# SERVICE BULLETIN

## CHECKING OF THE CRANKCASE

### ON ROTAX® ENGINE TYPE 912 AND 914 (SERIES)

#### SB-912-029 R3

see fig. 1

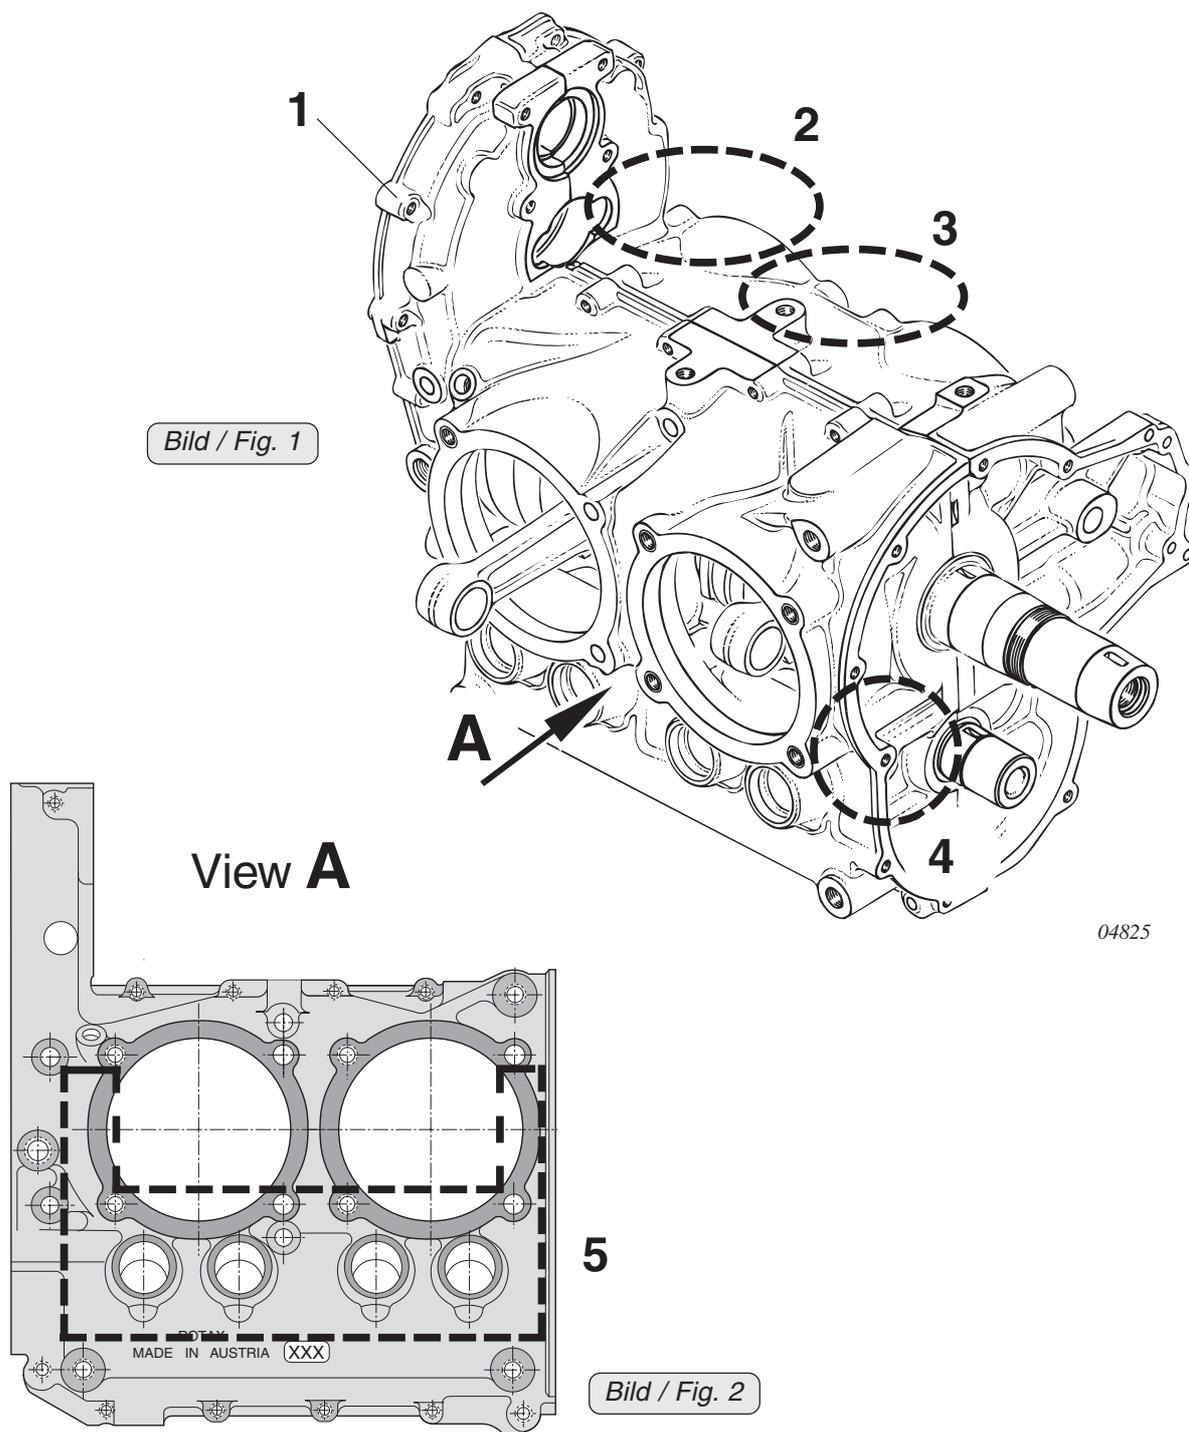
- Visually inspect the crankcase (1) and engine suspension for cracks in accordance with the relevant Maintenance Manual.

Visually inspect the crankcase especially:

- in the area of cylinder 1 upper side (2)
- between cylinder 1 and 3 upper side (3)
- in the area of cylinder 4 lower right side (4) and
- detailed inspect in the area (5). See view **A** fig. 2.

For those engines using the ROTAX<sup>®</sup> cooling air baffle. Visually inspect for oil leaks in area (2) and (3). If leaks are found, then further investigation to determine the cause of the oil leak is required. If the exact origin of the leak can not be determined i.e. governor, then removal of the cooling air baffle must be required.
